Reference: CPUC-ID: SA2020-870

Response to CPUC 2020 audit inspection findings report of PG&E's Cupertino
Substation Headquarters

**CPUC AUDIT FINDINGS OF PG&E CUPERTINO
SUBSTATION HEADQUARTERS
JULY 6-10, 2020**

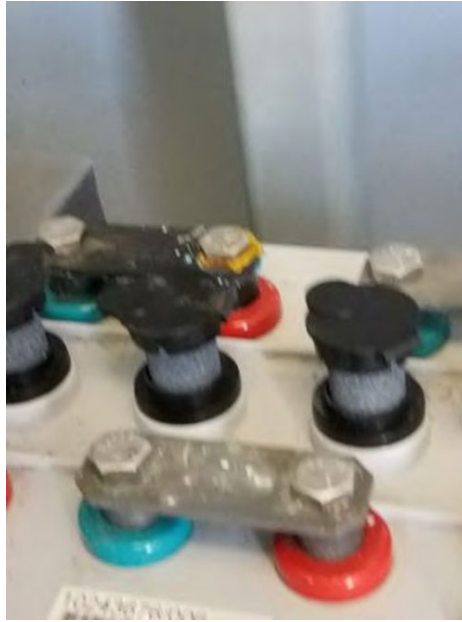
3.1. There is a bird nest in a fin of Transformer #1.

PG&E Response: The bird nesting material observed on Ames Transformer Bank #1 radiator fins was removed under Notification 119550956 and completed on 8/11/2020.

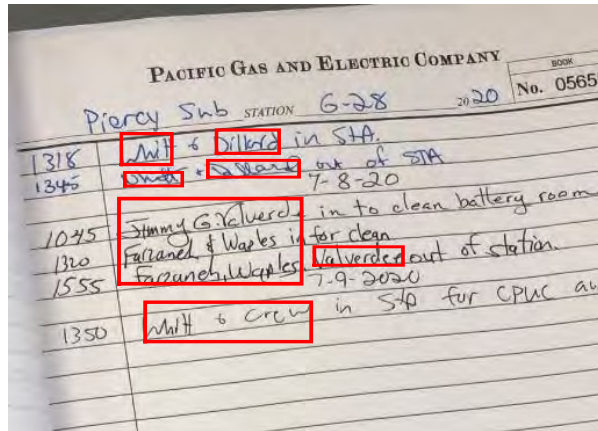
10.10. An NFPA 704 Diamond is missing from the front gate entry to the substation.

PG&E Response: The missing NFPA sign on Morgan Hill Substation Main Gate was installed during the October Station Inspection. No corrective notification was created to install the sign.

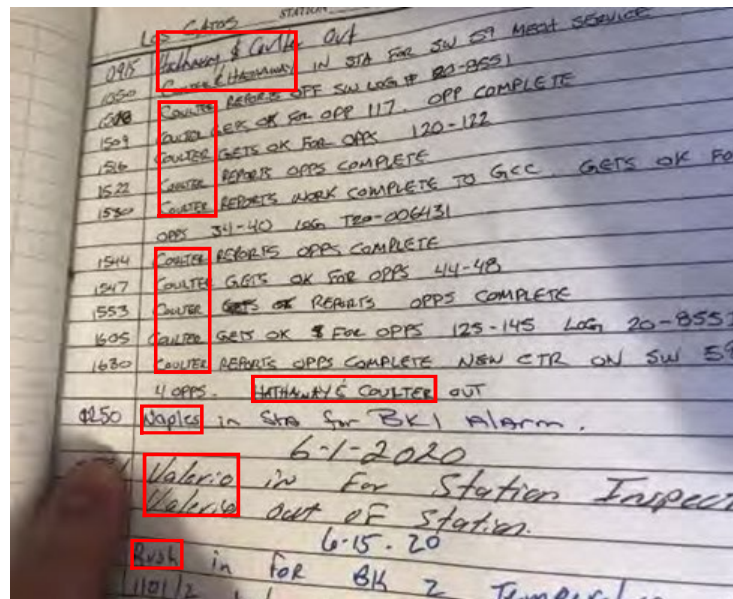
12.1. There is an abandoned IT cabinet.

PG&E Response: Notification 119552586 was created for PG&E's Telecommunication Group to evaluate further use of the communications cabinet observed at Los Gatos Substation. Based on their evaluation and recommendation, these cabinets still have active circuits that are "in-service" and should remain. This evaluation was completed on 8/03/2020 with no actions recommended at this time.
